Council Agenda Report

Subject: Consider a request from the applicant of the Cheval Hotel II to use portions of the Pine Street public right of way to accommodate hotel access and development

Date: August 15, 2017

Stormwater flow on February 17, 2017.

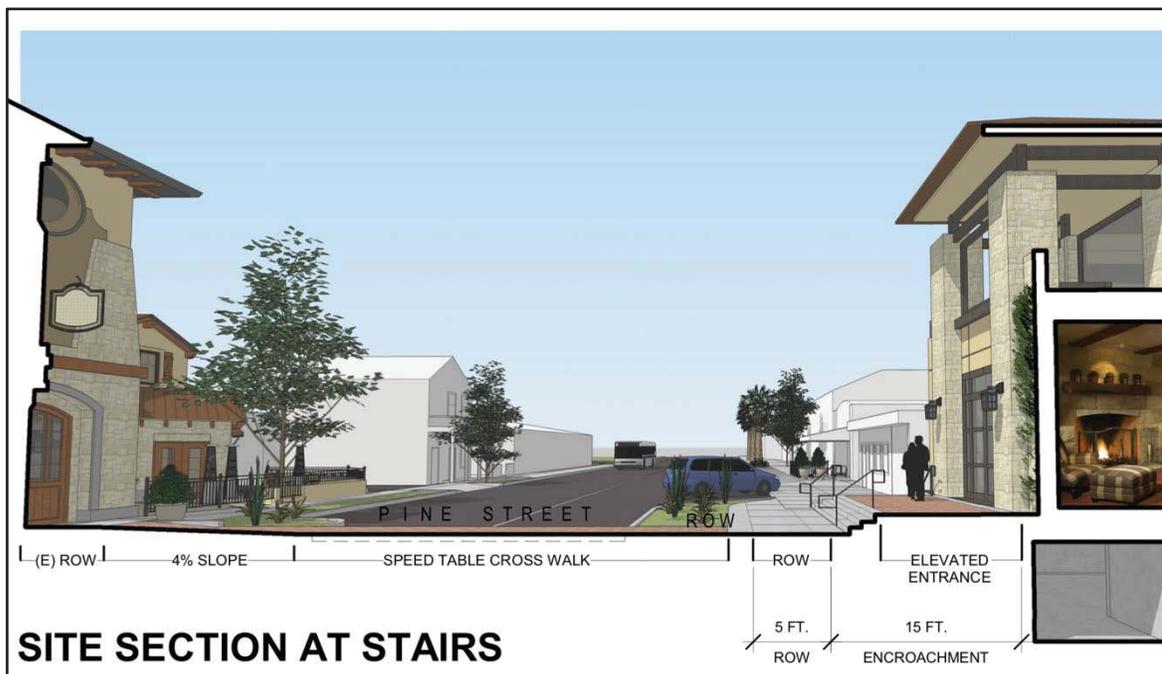
10. Engineering plans have not been submitted for the ramp or raised mid-block crosswalk. It is unclear if it will be possible to ramp down from the Hotel Cheval I front door to a raised crosswalk in the street because of elevation differences.
11. The proposed ramp and associated improvements will block stormwater flows along Pine Street. Stormwater gutter flow in this location is significant during intense rain events. Water is contained in the gutter, but the spread in the street is significant. The City has received complaints about the gutter flow from the applicant in the past.

Figure 1 - Stairs, Accessible Ramp, and Raised Patio Encroachment Area – 1,000 sq. ft.

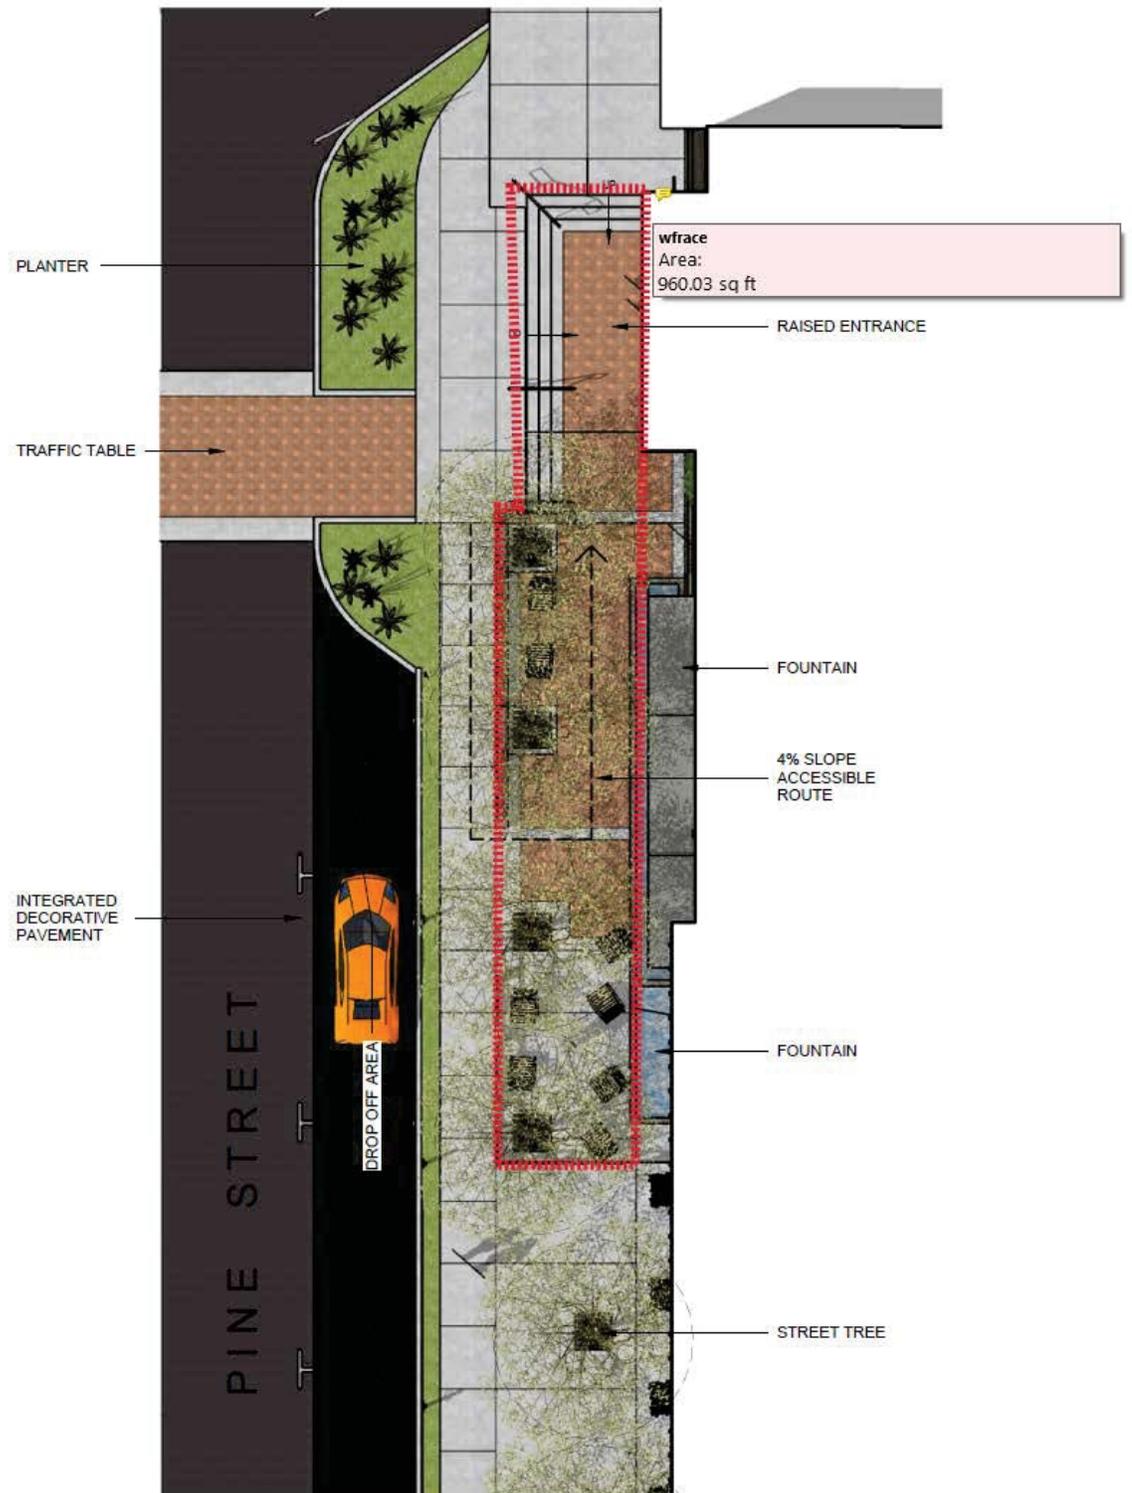
A stair, ramp, and patio are being proposed on Pine Street to allow the building first floor to be raised to accommodate parking under the structure see Figure 1, above. According to the applicant’s architect, the

building's first floor needs to be raised approximately two feet at the Pine Street right-of-way in order to accommodate three parking spaces under the building. The parking spaces will be a mix of accessible and normal parking spaces. According to the applicant's architect, the thickness of the first floor podium deck and the depth of the basement floor slab both contribute to the need to raise the first floor approximately 2 feet above the back of sidewalk on Pine Street. The first floor deck is thick to accommodate the structural loading and the basement floor slab elevation cannot be lowered any further. Therefore in order for guests to access the building, a stair and ramp will need to be provided on the Pine Street frontage. The applicant is proposing to install the stair and ramp in the right-of-way, rather than interior to the building, Figure 1. The applicant does not want to install the stair and ramp interior to the building because it will take space away from the front waiting room area, and will eliminate parking in the basement.

This proposal requires perpetual right-of-way usage since building entrance is predicated on the stair and ramp. Use of the right-of-way for building access has occurred in the past in the downtown. Usually, the building is historic and modifying the building is not often an option. However, this is a new building that could be built with the stair and ramp internal to the project or engineered to achieve street level access. Staff met with the applicant's architect and engineer on July 28th to discuss options for lowering the basement slab in order to eliminate or reduce the stairs and ramp. Ideas discussed include changing the cross grade on Railroad Street, lowering the curb height on Railroad Street, increasing the slope in the garage's interior and designing a thinner first floor podium deck. In addition, options such as raising the Pine Street sidewalk was also discussed. Staff has requested that the applicant consider these options in the design to lower the grade differential, but the applicant has not been provided with any alternative options and wishes to pursue the original concept.

Staff is seeking direction from Council if use of the right-of-way for the proposed Hotel's access is acceptable. If the use is acceptable, staff is also seeking direction on the Council's comfort with amount of space the applicant is proposing to use. The current proposal consists of approximately 1,000 square feet of sidewalk. Options include decreasing the stair width and depth to minimum required for access, as well as eliminating the café seating area and just including bi-directional ramps. Another option is to move forward with the proposed use or a version between the proposed and absolute minimum discussed above. Staff recommends that any option chosen should leave enough space for a 10' sidewalk.

1. To further refine the project and require the applicant to submit additional information that:
 - a. Considers additional options to lower the first floor elevation of the hotel to reduce eliminated the steps and ramp on Pine Street.

- b. Requires any structure with stairs to include ramps dual directional accessibility ramps, similar to the Powell's Candy Store ramp.
 - c. Reduces the overall size of the public right of way encroachment.
 - d. Maintains a minimum 10-foot public sidewalk on Pine Street.
 - e. Provides engineering details of the mid-block crosswalk and ramps on Pine Street that demonstrate the feasibility with existing grades, disabled access requirements, and stormwater drainage issues.
2. To work with the City Attorney to evaluate the issues and options of either granting an irrevocable encroachment permit or process a right of way abandonment to accommodate the project.
